TECHNICAL INFORMATION

SUBJECT: Carburetor on **ECHO CS-2511TES, shindaiwa 251TCs and 251Ts**

Number: Y2019-672
Issued: Sep. 30, 2019

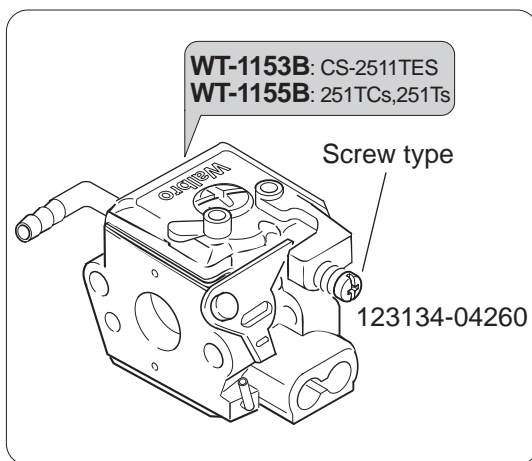
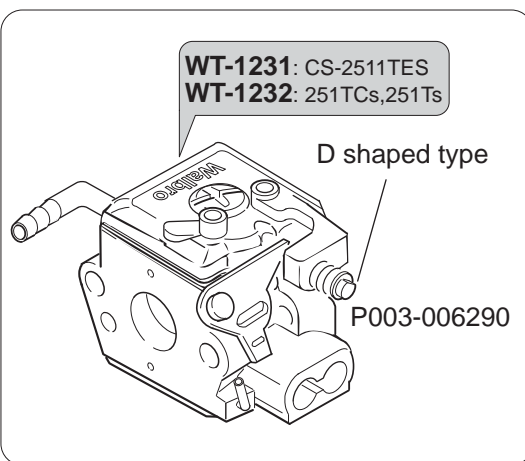
<p>Changed shape of throttle adjust screw to prevent improper adjustment by user.</p>		
CS-2511TES(38)	Serial Number 38010840 and before	Serial Number 38010841** and after
251TCs(38)	Serial Number 38001840 and before	Serial Number 38001841** and after
251Ts(38)	Serial Number 38002360 and before	Serial Number 38002361** and after
CS-2511TES(33)	Serial Number 33999999* and before	For spare parts**
CS-2511TES(37)	Serial Number 37999999* and before	
251TCs(37)	Serial Number 37999999* and before	
251Ts(37)	Serial Number 37999999* and before	
Throttle adjust screw	 <p>WT-1153B: CS-2511TES WT-1155B: 251TCs, 251Ts</p> <p>Screw type</p> <p>123134-04260</p>	 <p>WT-1231: CS-2511TES WT-1232: 251TCs, 251Ts</p> <p>D shaped type</p> <p>P003-006290</p>
Carburetor assembly	<p>A021-004522: CS-2511TES A021-004552: 251TCs, 251Ts</p>	<p>A021-005160: CS-2511TES A021-005170: 251TCs, 251Ts</p>
<p>Throttle adjust screw P003-006290 can be used on the unit before this change. Carburetor assembly A021-005160 can be used on the unit before this change. Carburetor assembly A021-005170 can be used on the unit before this change.</p>

** When replacing carburetor of unit with 'P' or 'P[1]' mark ignition coil, use carburetor with D shaped type throttle adjust screw. Refer to Technical Information No.Y2018-660.
